**APPENDIX 4B**

**DETAILED DRAWINGS FOR THE 200 AREA EFFLUENT TREATMENT FACILITY  
CONTAINER STORAGE AREA AND TANK SYSTEMS**

1. ECN 647892

ECN 647892, pg 20 of 27  
14-2-89063, SW 1

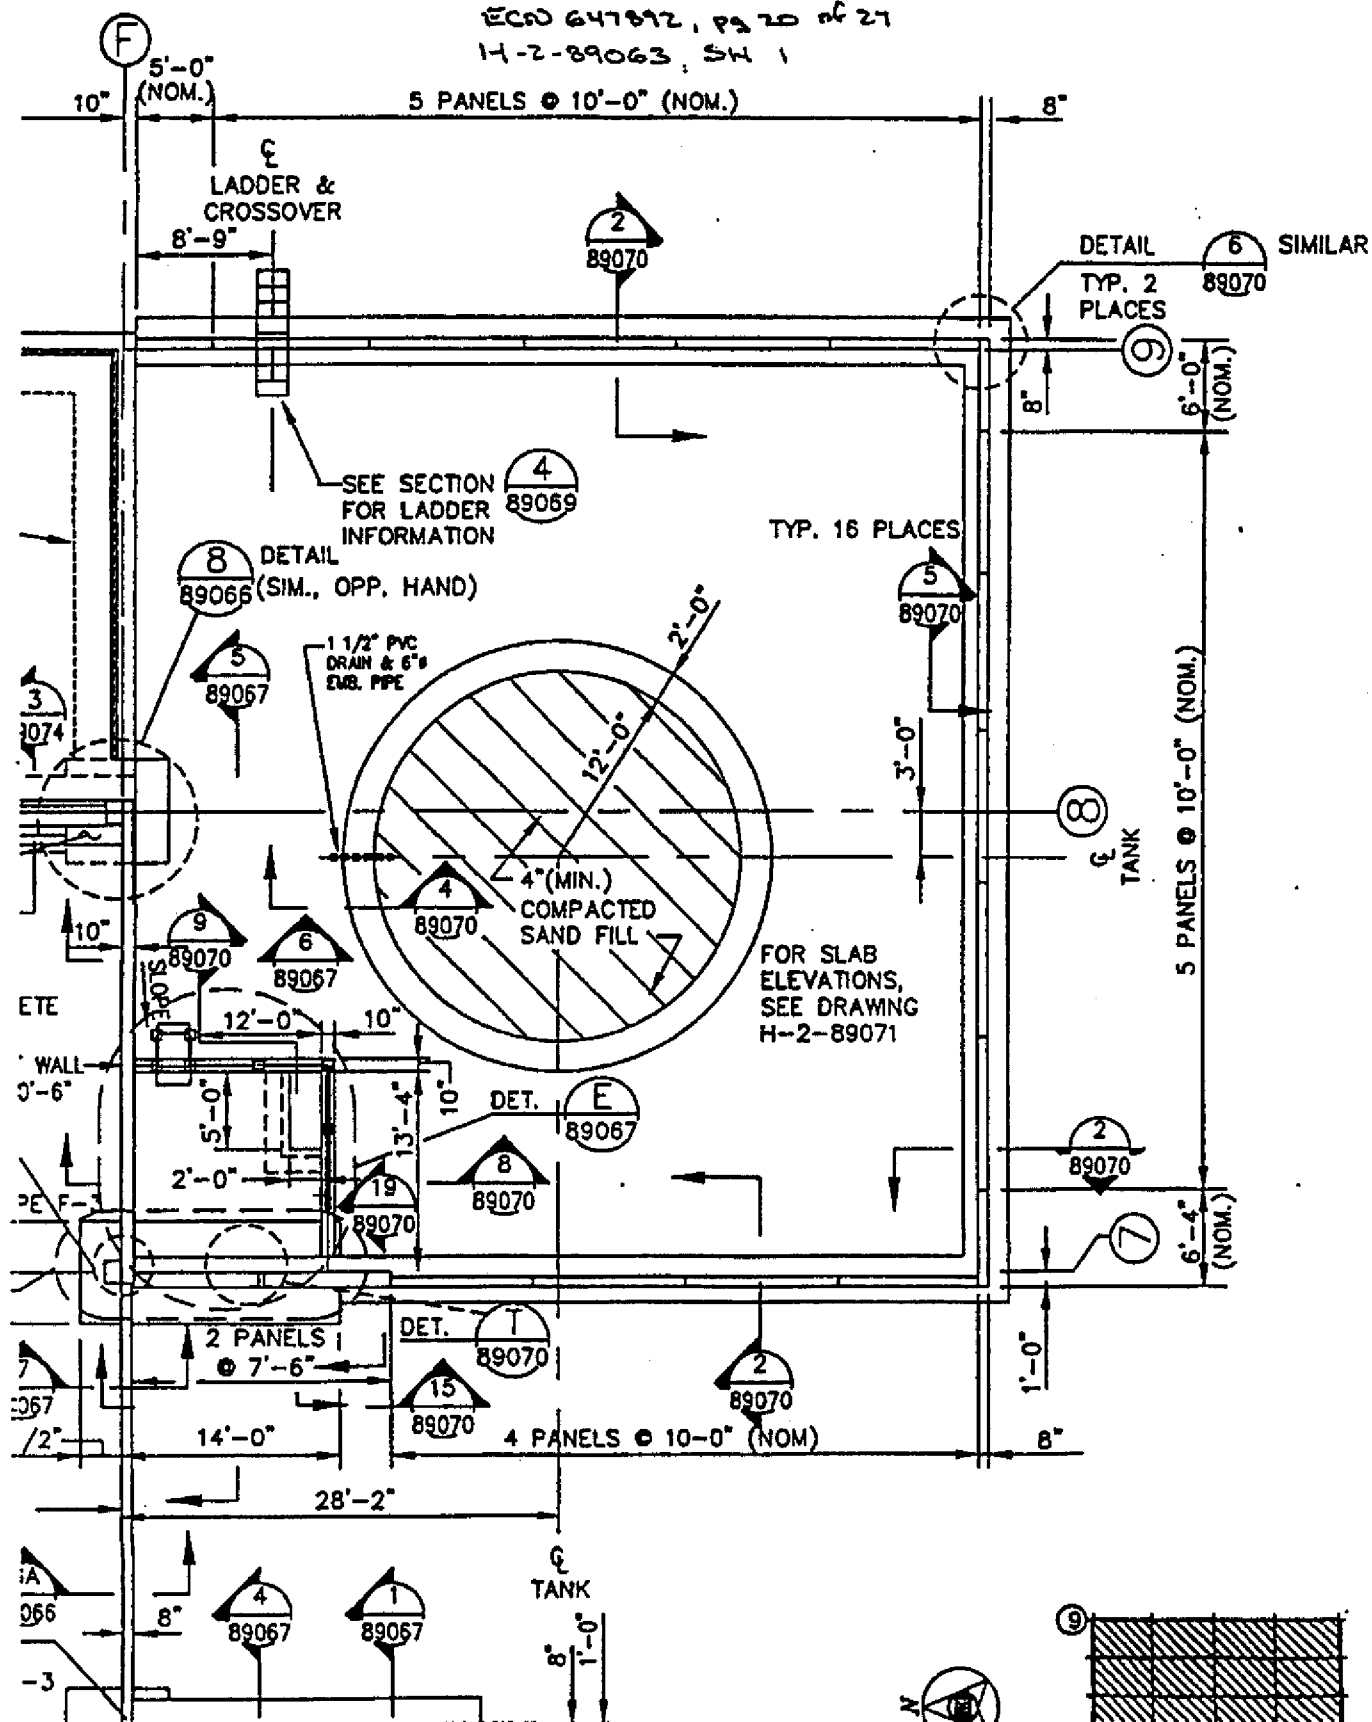
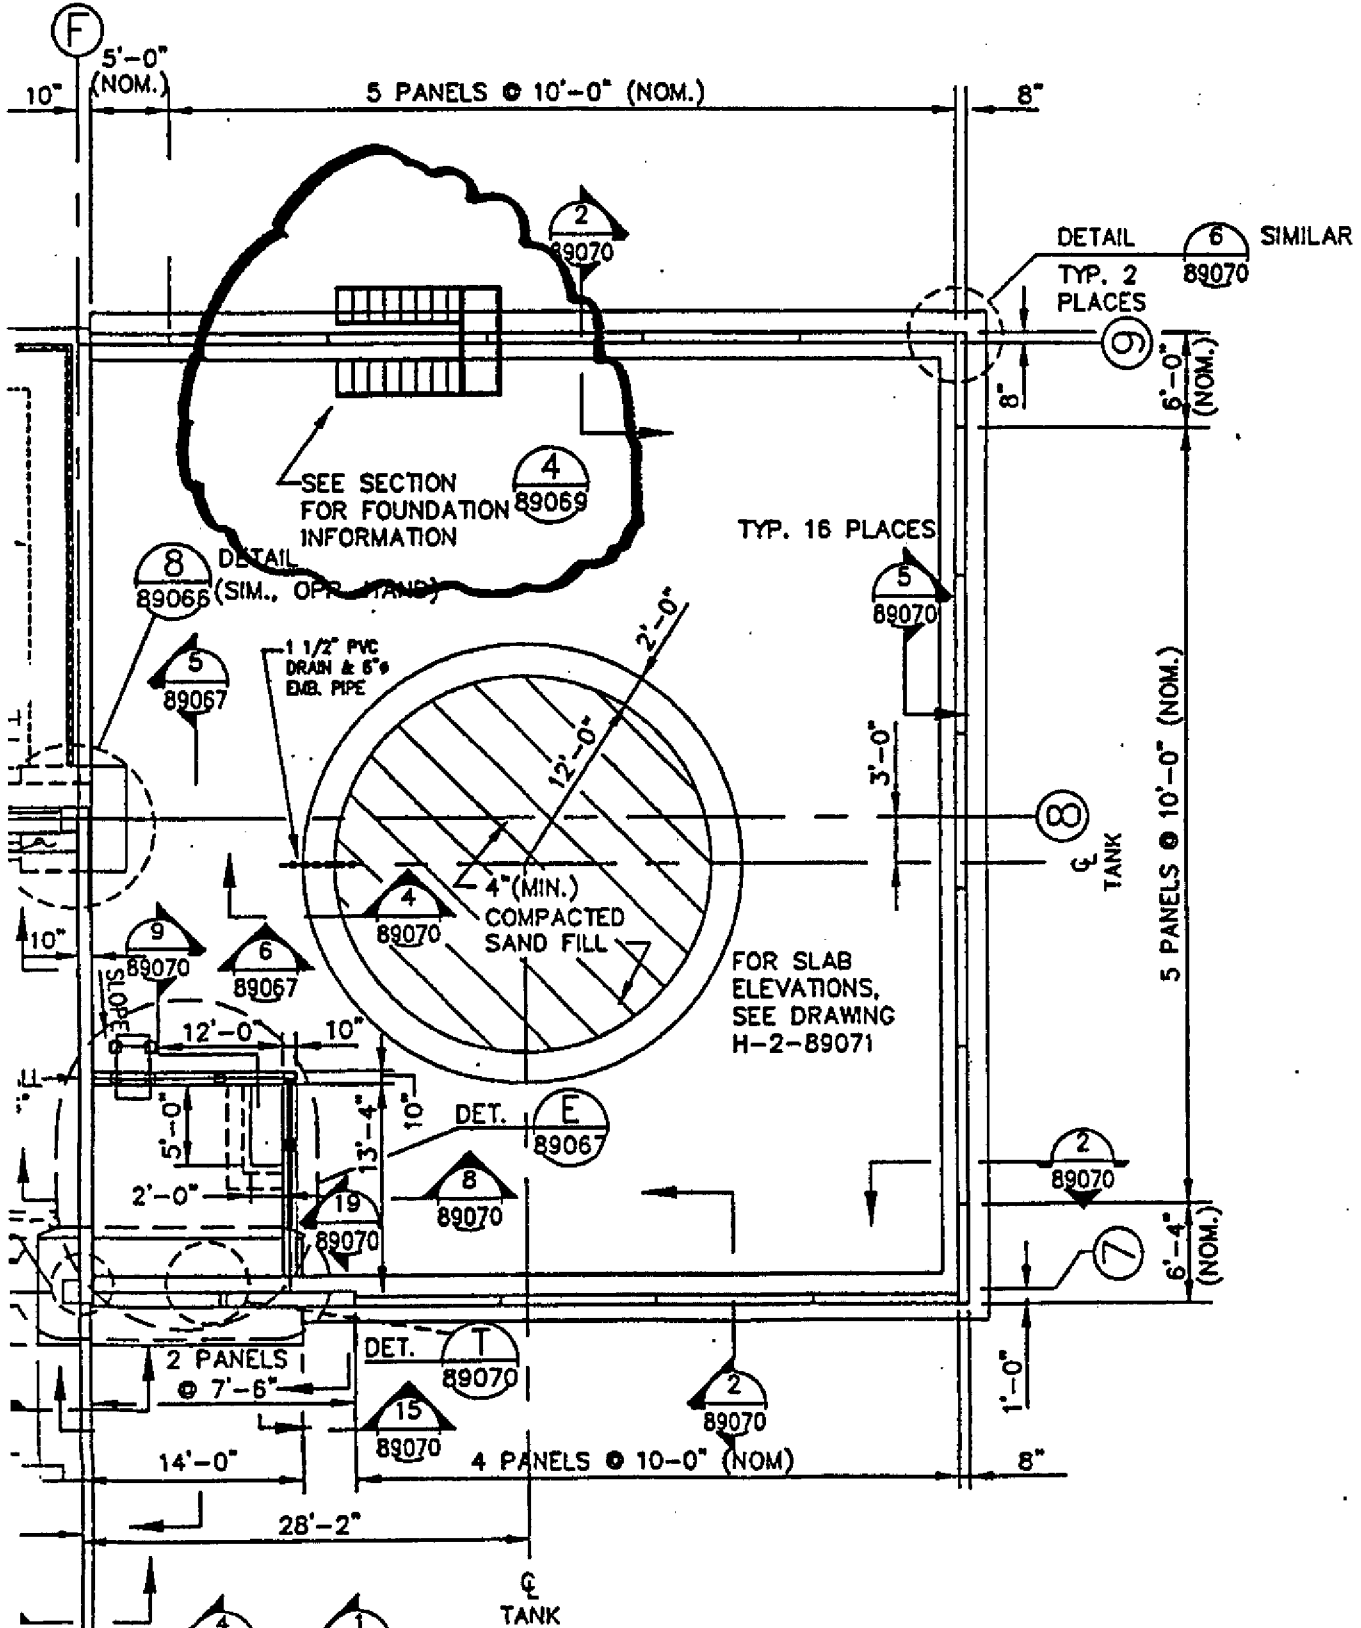
- H-2-89063, Sh 1, Zone F-2: Replace ladder with stairway. Delete 8'-9" dimension and ladder & crossover centerline callout. Change Section 4, Dwg. 89069 callout to read "See Section For Foundation Information".

H-2-89068, SH 1

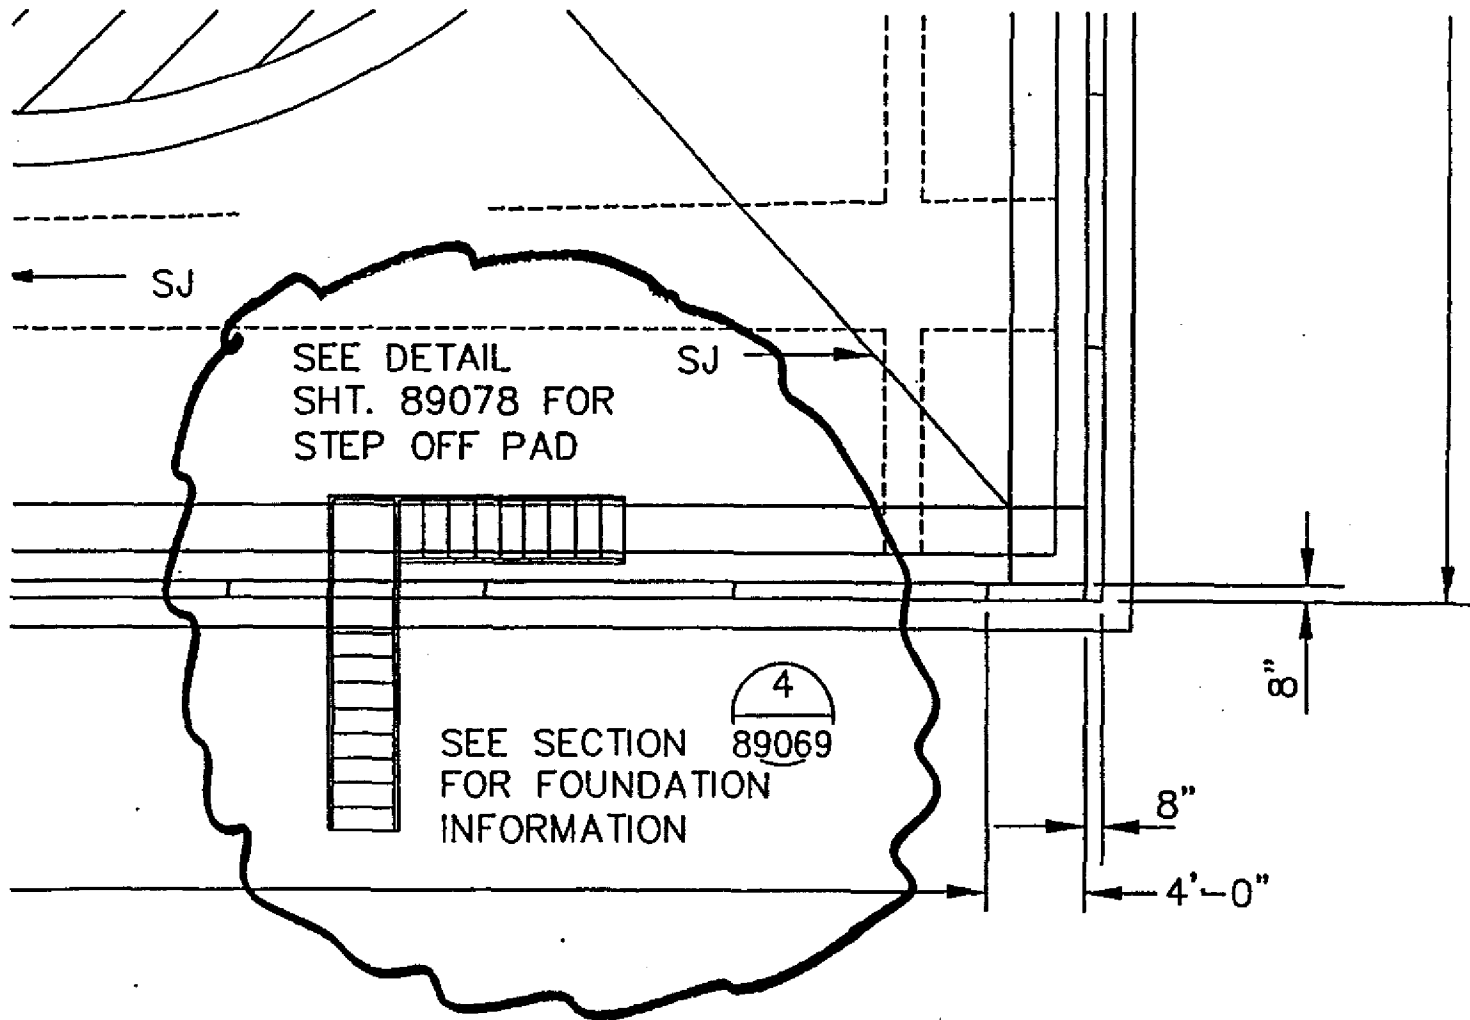
- H-2-89068, Sh 1, Zone C-3: Replace ladder with stairway. Delete 10'-0" & 3'-5 1/2" dimensions, landing and ladder & crossover centerline callout. Change callout to read "See Section For Foundation Information" with reference to Dwg. 89069, Section 4.

ECNO 64789Z, PG 24 OF 27  
14-2-89069, SHI

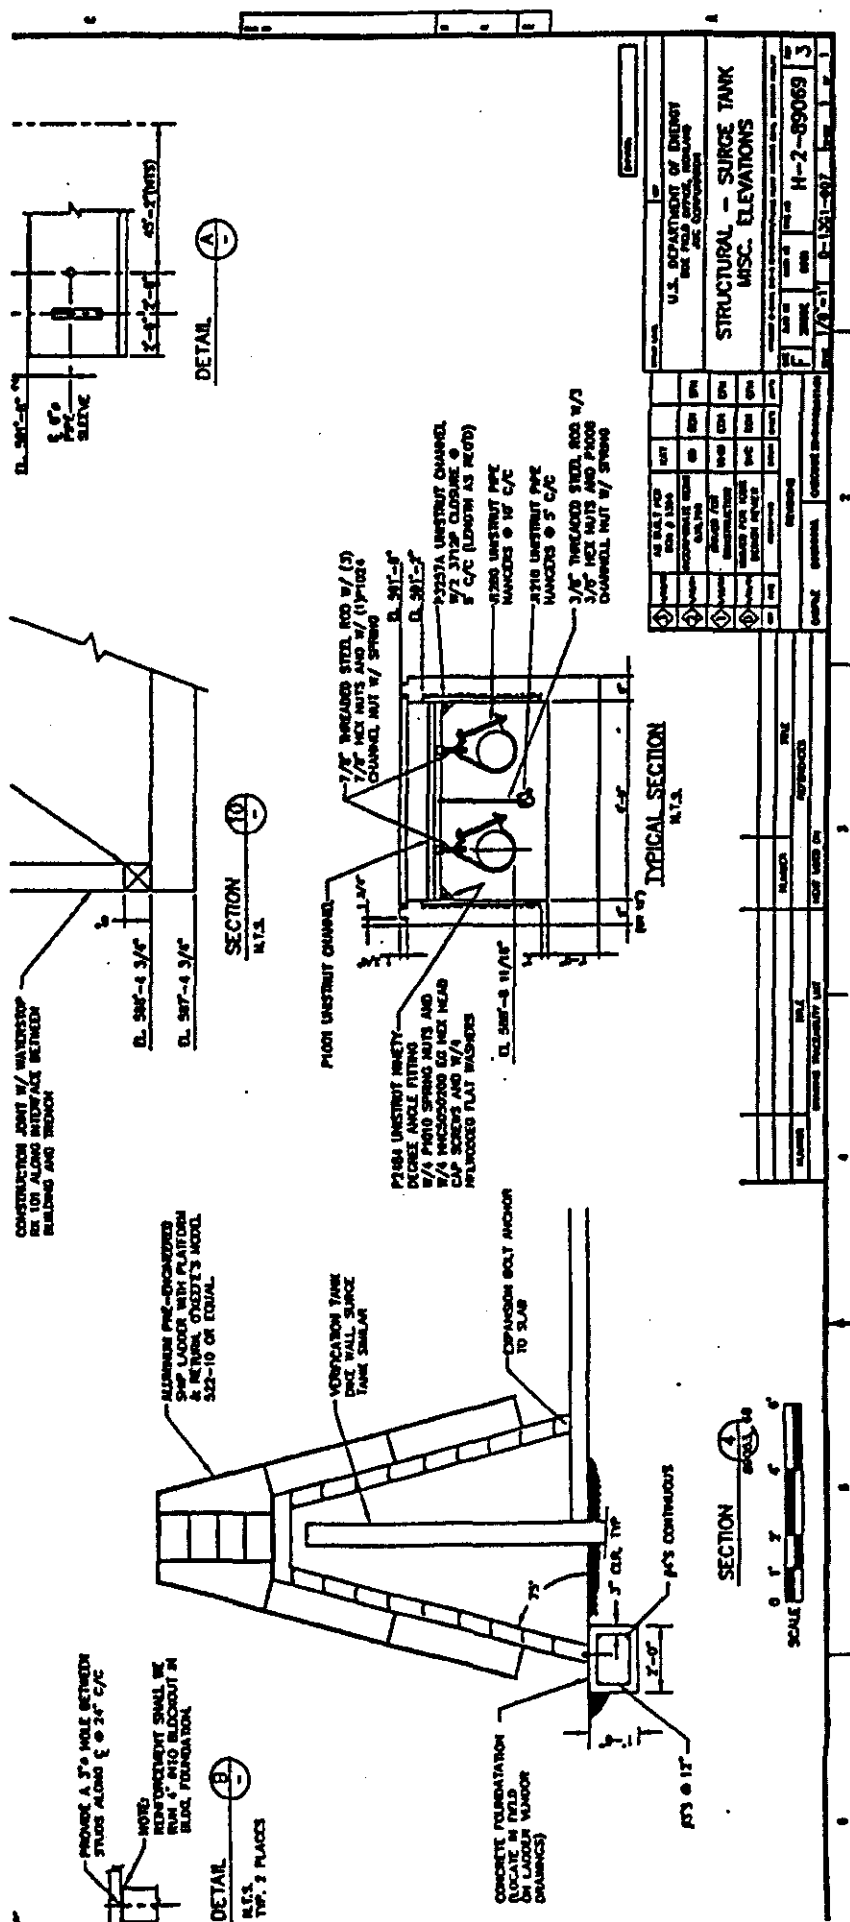
- H-2-89069, Sh 1, Zone A-6: Add "minimum" to foundation width dimension (2'-0") callout. Change foundation text to read "Ladder Or Stairway Concrete Foundation (Locate In Field)". Change ladder description text to read "Aluminum Pre-Engineered Ship Ladder With Platform & Return, O'Keefe's Model 522-10 Or Equal, Or Aluminum Pre-Engineered Stairway. See VI Supp. 50054 For Stairway Detail."

H-2-817974, Sheet 1, Rev. 2, Zone C-7 to D-7

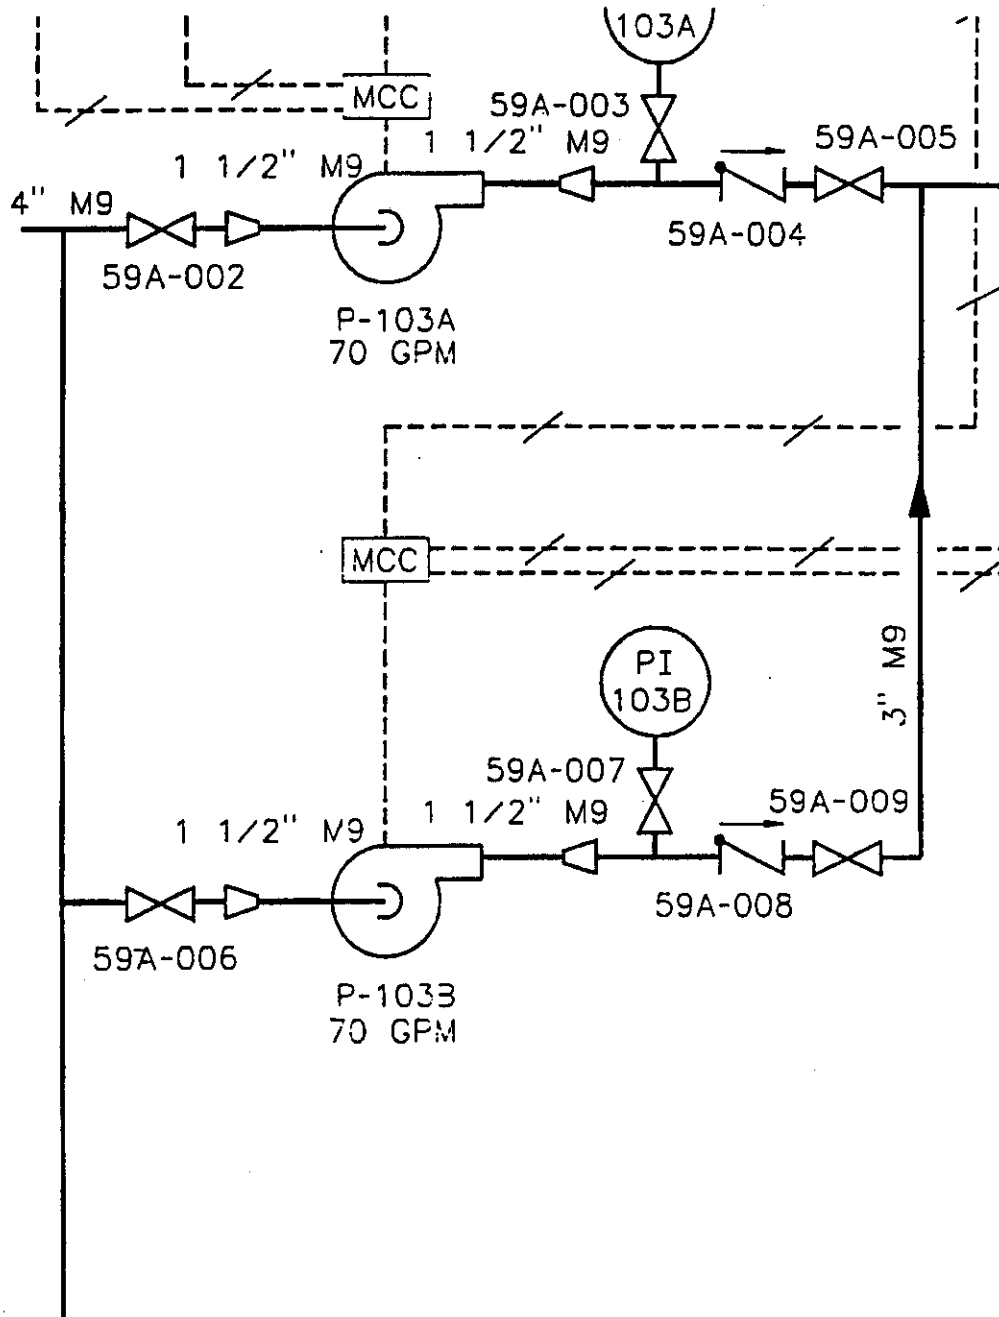
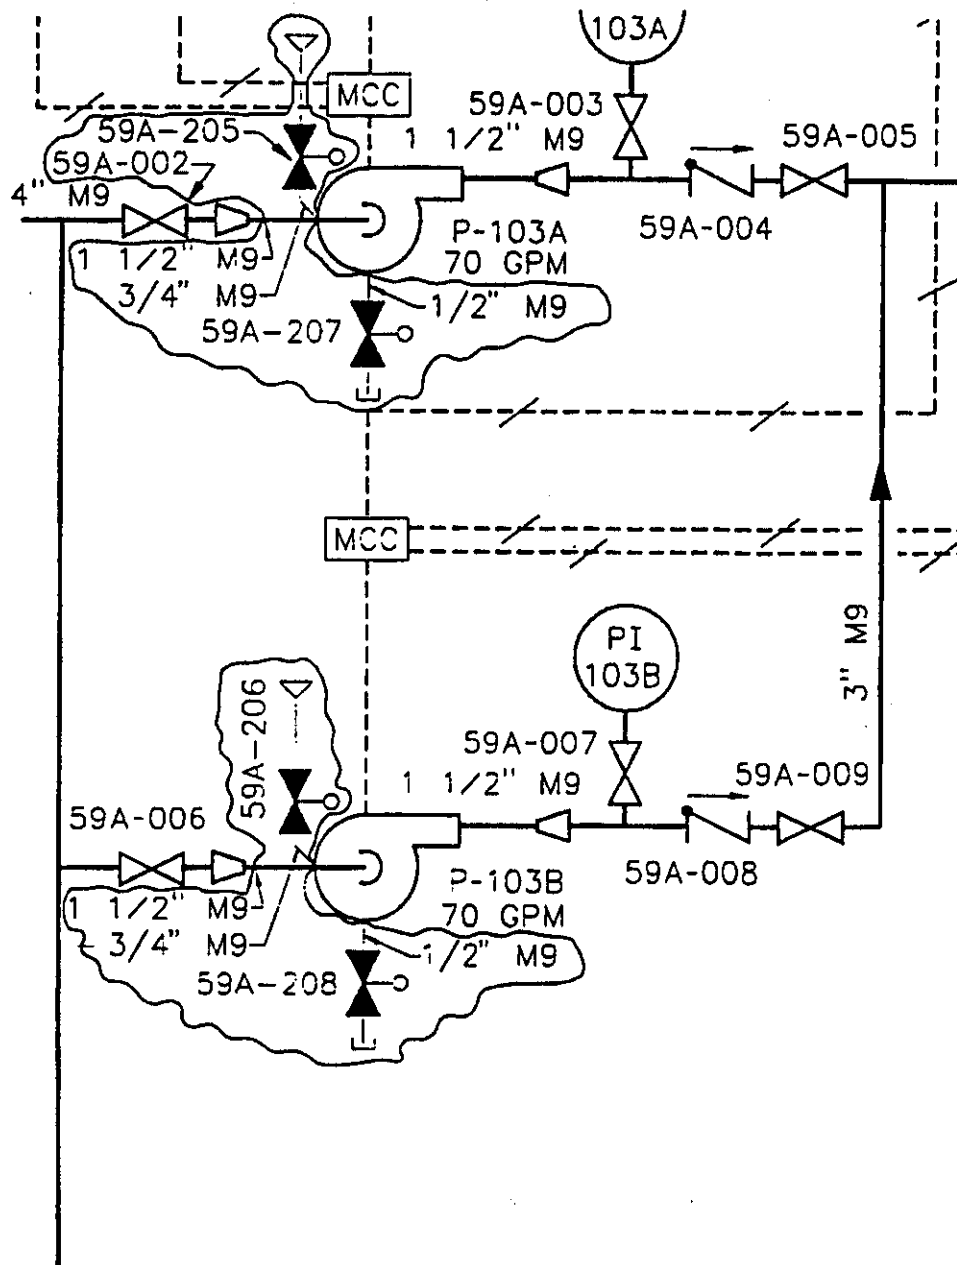
IS:

CHANGE TO:
